Access Compliance Report Public Rights-of-Way (Pedestrian Signals)

Main Street: **BEACH_BLV** Cross Street: **HAZARD_AVE** Location: **E**

ADA ID: **SGRK220202125434** Signal Type: **One Push Button-APS** Overall Compliance: **No** Severity Scores: **BTN 1: 25** **BTN 2: N/A** **No BTN: N/A**

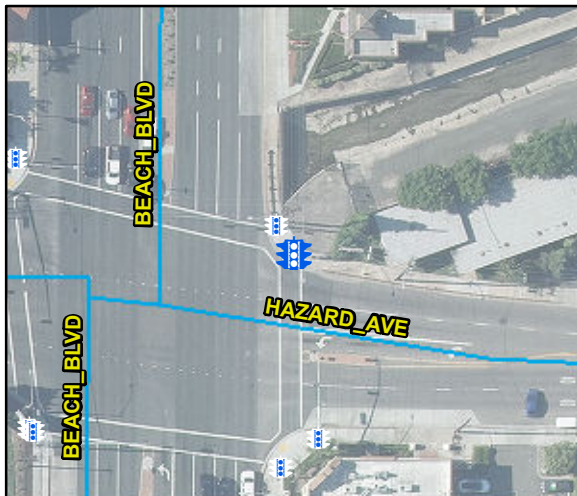
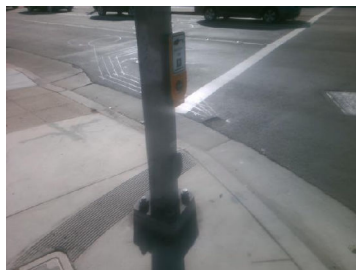
OC Std/PROW: **R404.2**

Possible Solutions: Remove and Replace Clear Space.
